CITY OF PORTSMOUTH, NH

MADBURY WTP UPGRADE AND  
BELLAMY RESERVOIR IMPROVEMENTS

**RESPONSE TO BIDDERS QUESTIONS No. 2**  
**AND**  
**ADDENDUM No. 3**  
2/24/09

PROJ. NO. <u>09572-000</u>	ADDENDUM NO. <u>3</u>
SKETCH BY: <u>T.NARDONE</u>	REF. DWG. NO. <u>A-10</u>
DATE: <u>FEB. 18 2009</u>	SKETCH NO. <u>A10-SK-01</u>

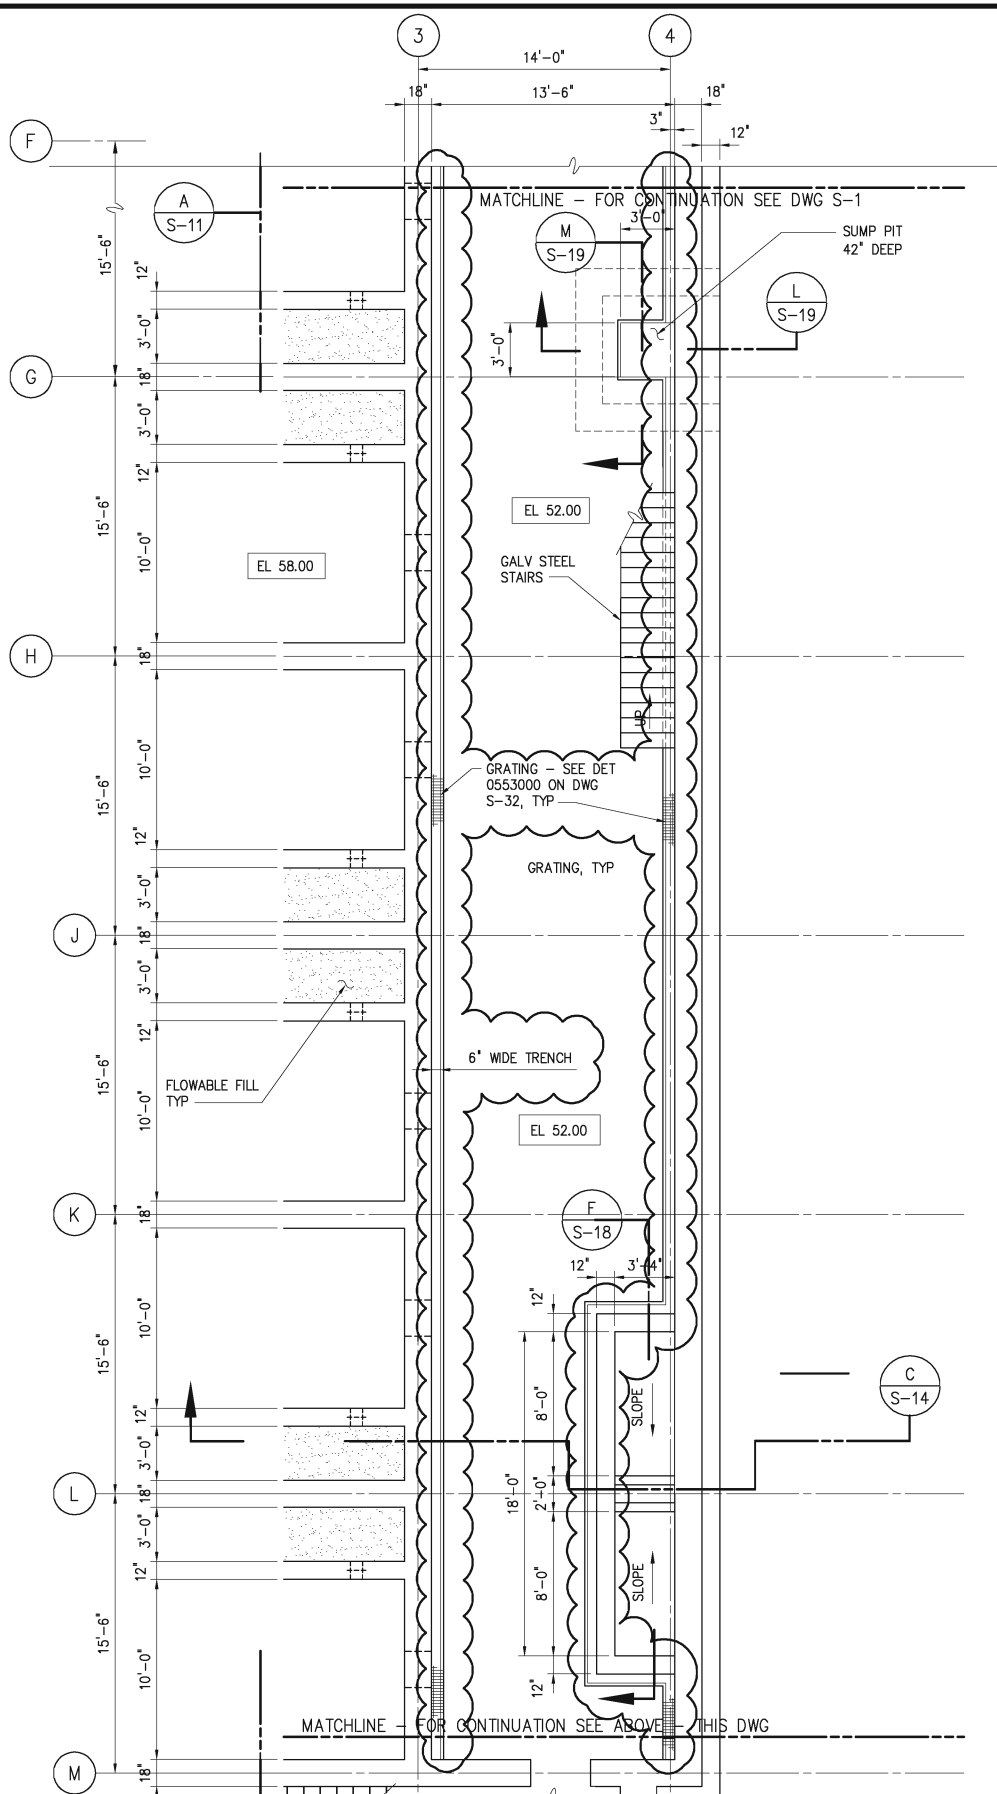
- A. Add one ship ladder along column line E.9 and centered on “Roof Pavers”
- B. Add one ship ladder along column line M and centered on “Roof Pavers”
- C. Delete Detail 1 in its entirety and replace with Detail 1 in attached Sketch A10-SK-01
- D. Add label at each ship ladder to state “Ship Ladder- See Detail 1/A10.”

PROJ. NO. <b>09572-000</b>	ADDENDUM NO. <b>3</b>
SKETCH BY: <b>D. KELLOGG</b>	REF. DWG. NO. <b>S-2</b>
DATE: <b>FEB. 23 2009</b>	SKETCH NO. <b>S2-SK-01</b>

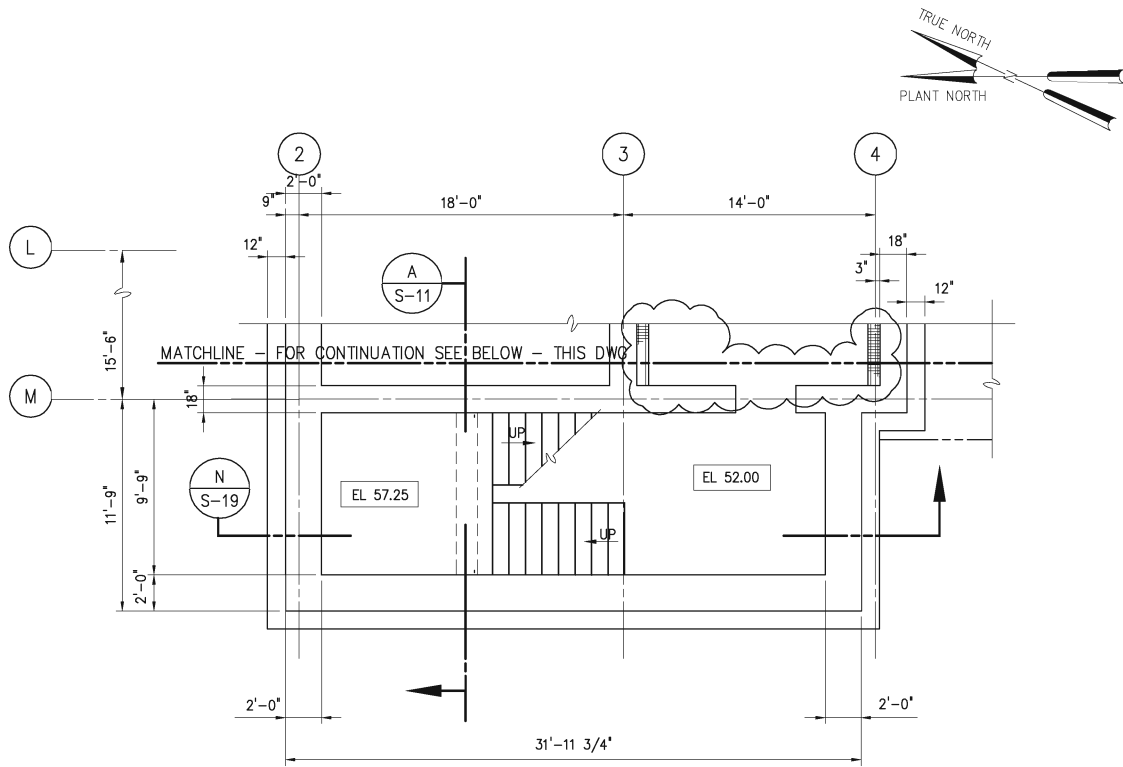
- 3-2. Lower Gallery Level Plan, on Drawing S-2, details the Floated Solids Transfer Tank as being 3'-4" wide. Section C/S-14 indicates a wider area. Also, what is the depth of the supported slab covering this Tank? Please clarify.  
*Floated Solids Tank is 3'-4" wide. Top slab is 10". See Addendum 3, Item 3-23 and 3-27*

- A. See attached Sketches S2-SK-01 and S2-SK-02 for modifications to the design

PROJ. NO. <b>09572-000</b>	ADDENDUM NO. <b>3</b>
SKETCH BY: <b>D. KELLOGG</b>	REF. DWG. NO. <b>S-1</b>
DATE: <b>FEB. 23 2009</b>	SKETCH NO. <b>S1-SK-02</b>

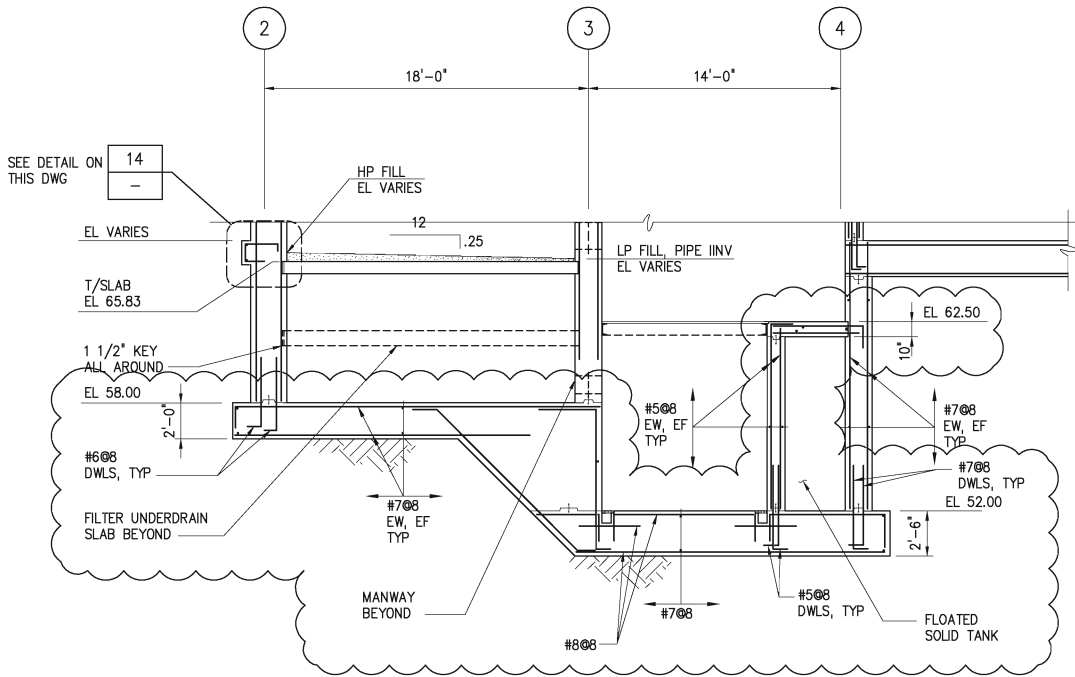
- A. See attached Sketch S1-SK-01 for modifications to the design
